Access Compliance Report

Public Rights-of-Way

Intersection ID: 19146	Main Street: TYVOLA_RD	Cross Street: WEDGEWOOD_DR	Location: SE
ADA ID: B8B6C7DA2371	Ramp Type: PerpDiag	Initial Pass/Fail: Pass	Overall Compliance: No
			Severity Score: 10.25

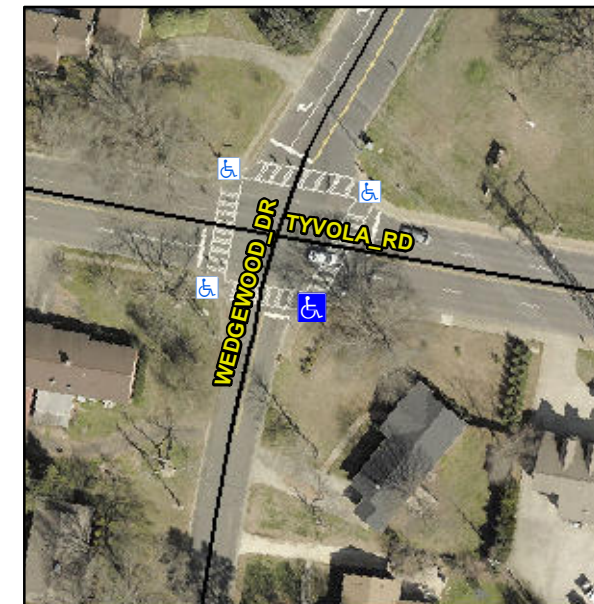
Not Found, R304.5.3, R304.2.1, R304.2.2-Perp, R304.3.2-Para, R305, R302.7

Remove & Replace Curb Ramp With Two New Directional Ramps or Equivalent.
